TO: Development Review Board
FROM: Kirk Dressing, Associate Planner
DATE: August 18, 2026
RE: ZP-26-264; 48 Blodgett Street

File: ZP-26-264

Request: Proposed addition of second floor and attic over existing house footprint. Proposal includes first floor connector addition to existing garage.

1 NORTH ELEVATION - PROPOSED
1/4" = 1'-0"

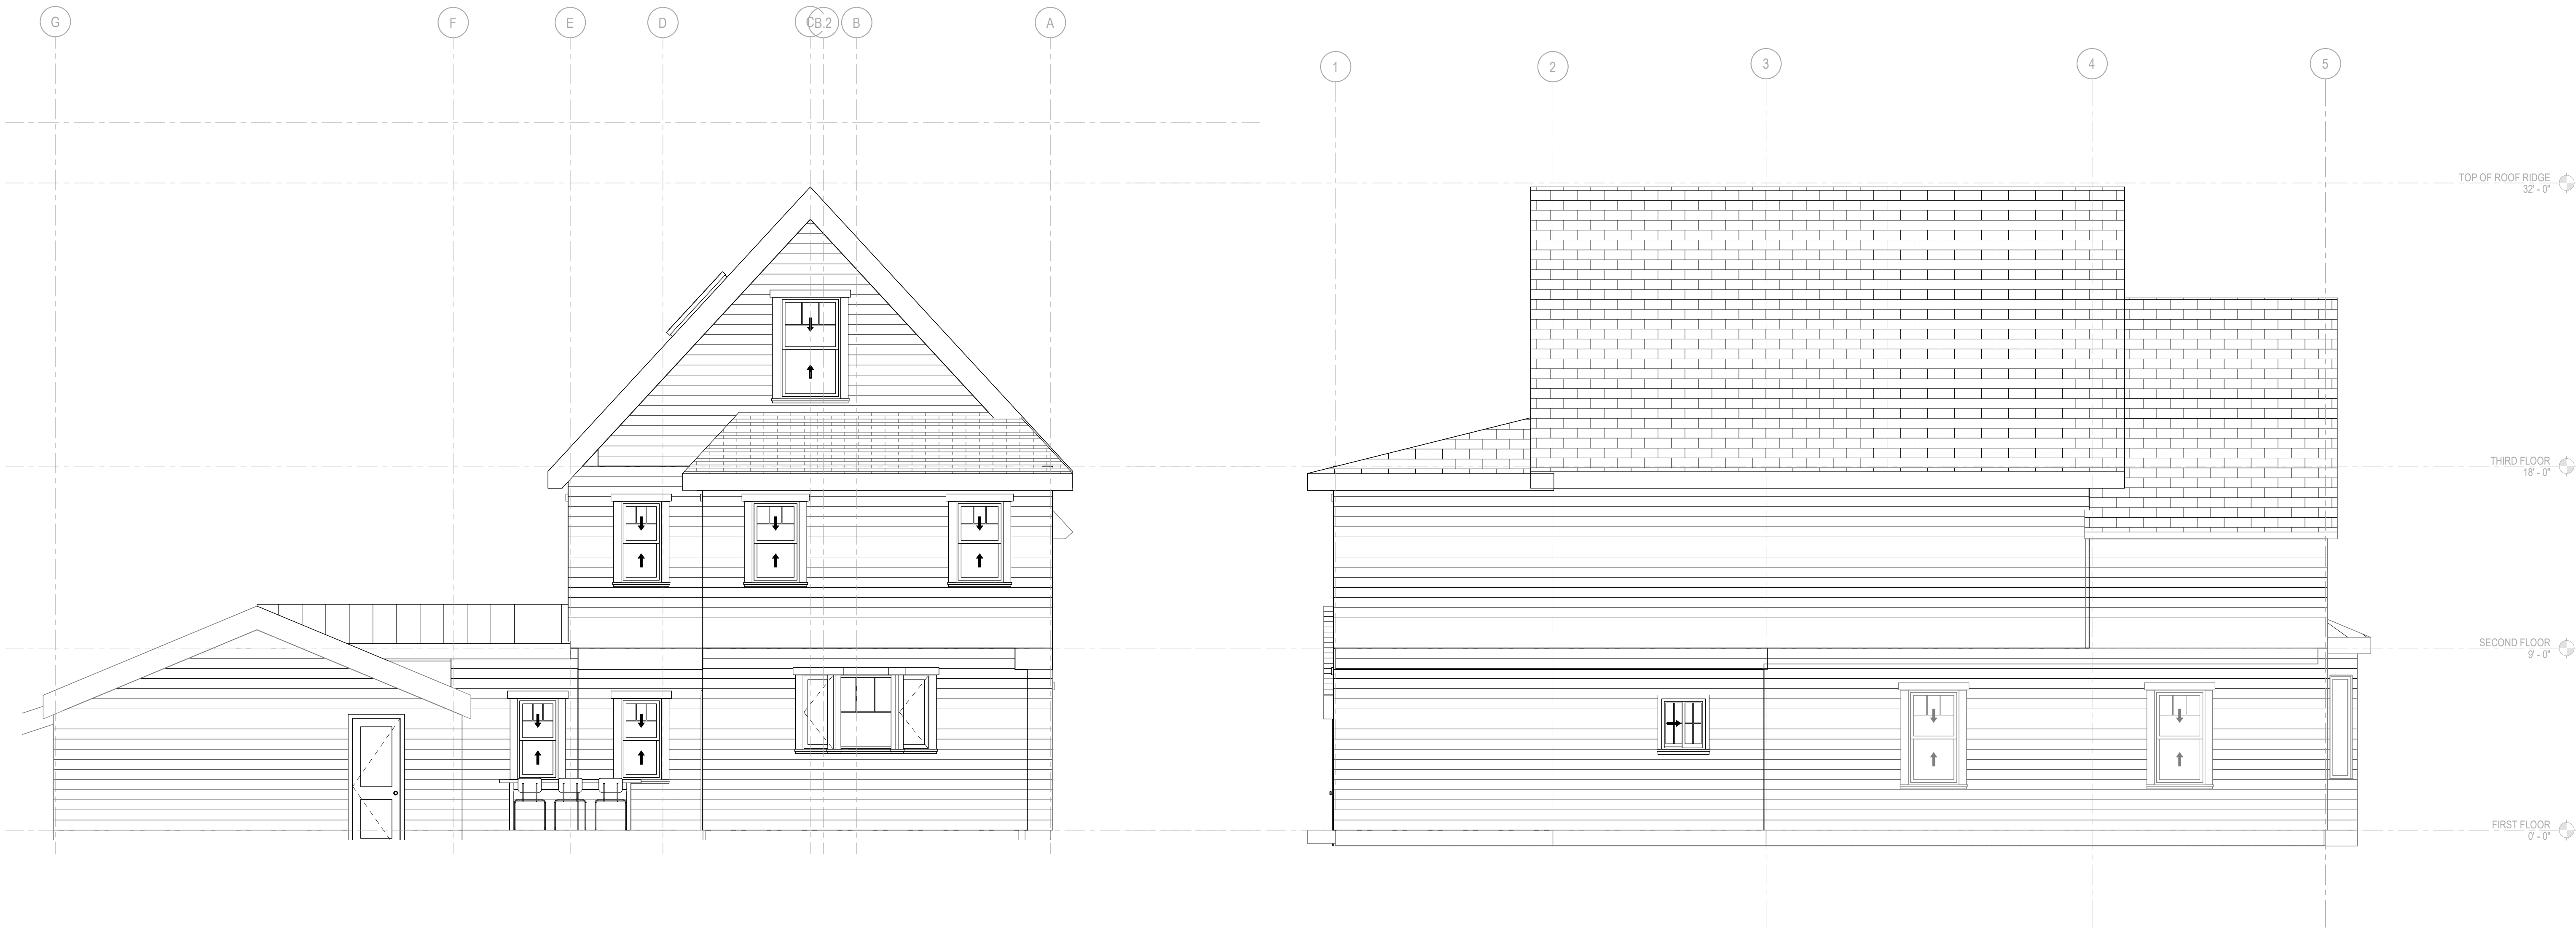
See Table 4.4.5-1 above. The proposed 1-story addition with attic will create new non-conformity to side yard setback on the north elevation. DRB discretionary review is warranted under Section 5.3.5 (a), below.

The proposed addition is placed on the existing house footprint, but as expanded vertically into a full second story with third story attic introduces expanded non-conformity to side yard setback. The addition otherwise will not create any new non-conformity, and is not anticipated to have an undue adverse impact on adjoining properties or public interest. The building official may require

The only new building entrance proposed is a sliding door leading to the rear deck, which will not be visible from the street. The only additional opening to the front façade of the building is a witch's window. The southern façade window layout will change with the removal of entry porch windows as well as the relocation of first-story windows to accommodate the garage connection. Skylights and second floor windows are also proposed. The windows depicted on the elevations appear to be different from the existing, and no spec sheets have been provided for the proposed windows. Proposed window spec sheets, and clarification about whether or not

- c. Clarification as to whether or not existing windows are proposed to be replaced.
 - d. Proposed window spec sheets shall be provided for staff review and approval.

1 LOT SETBACK MEASUREMENTS
1" = 10'-0"

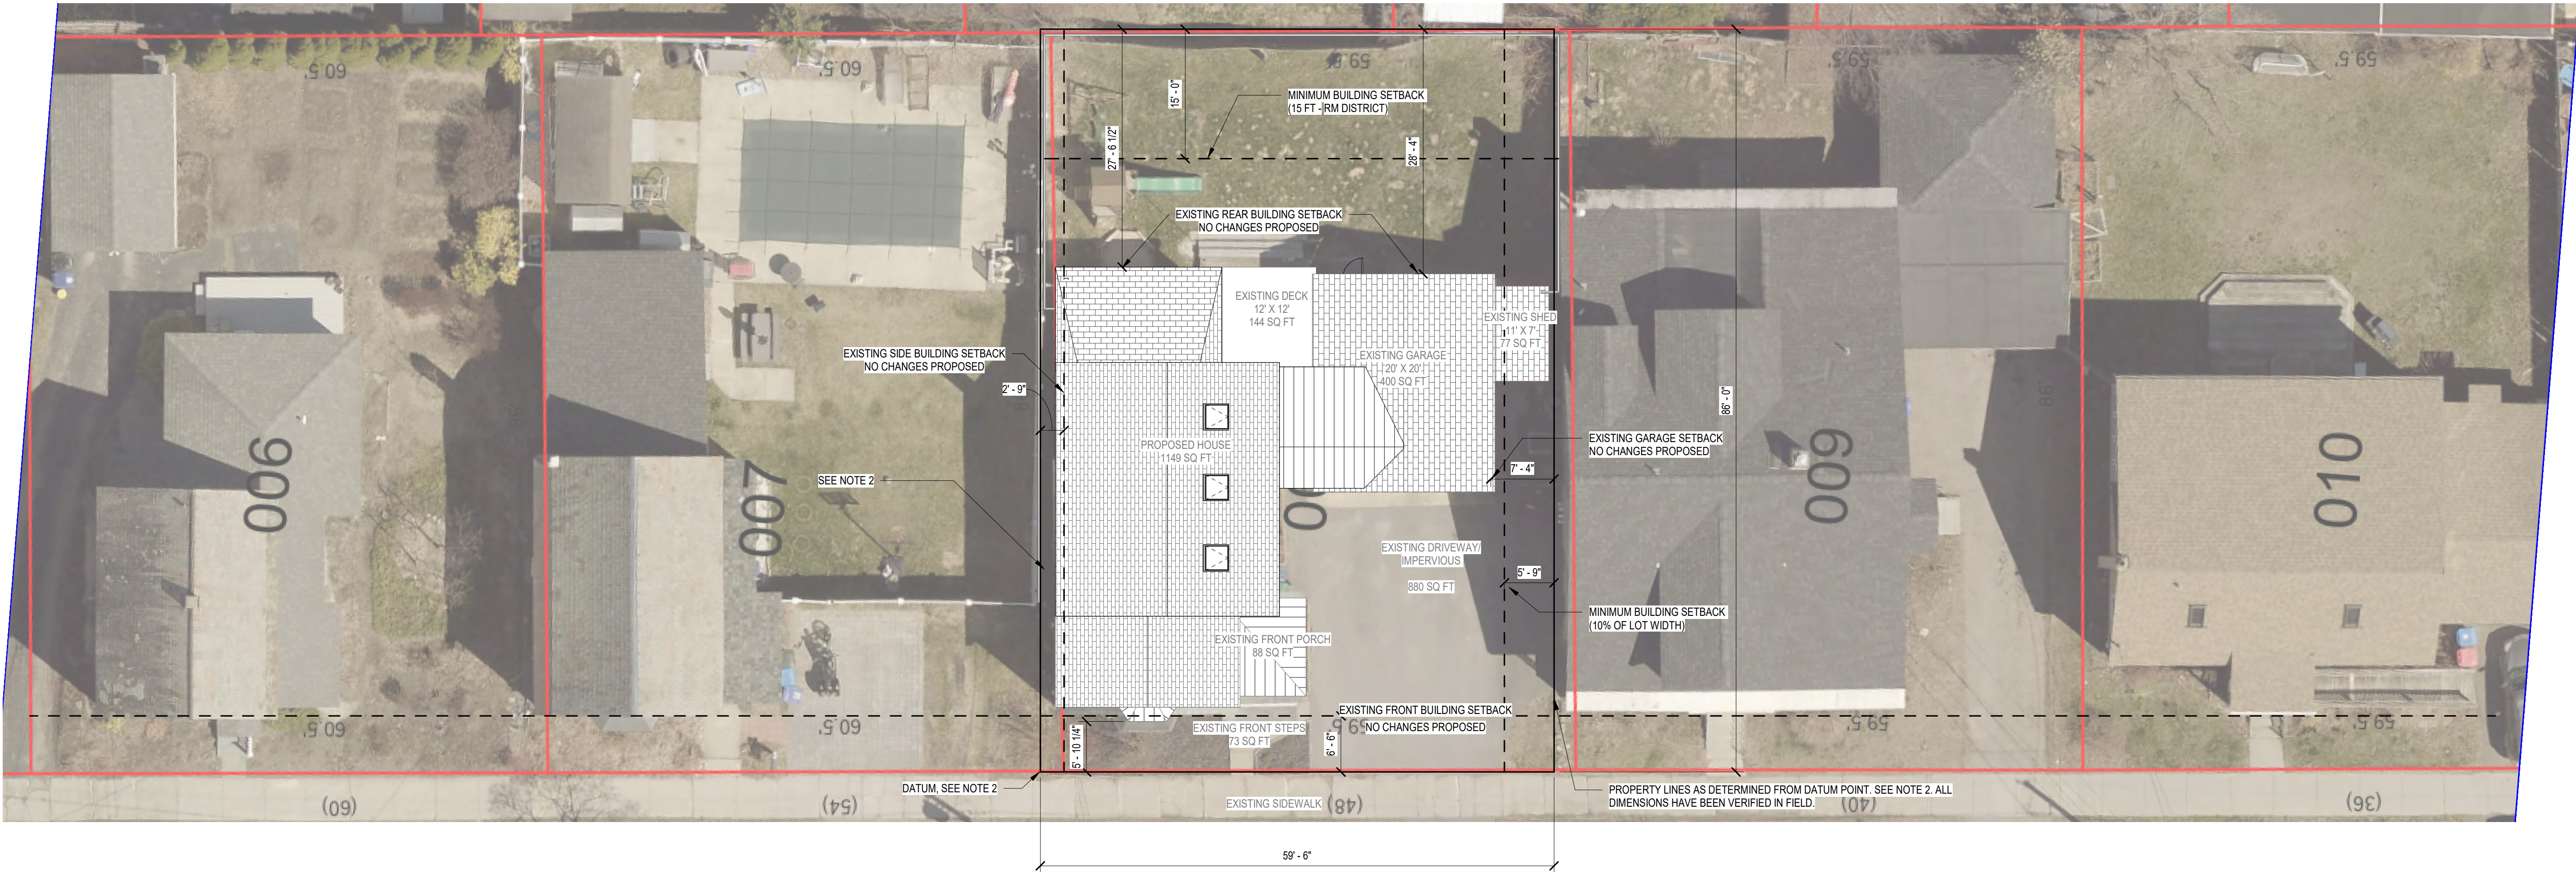
Affirmative finding, with DRB discretionary review of vertical expansion within a required setback. See Section 5.3.5 (a).
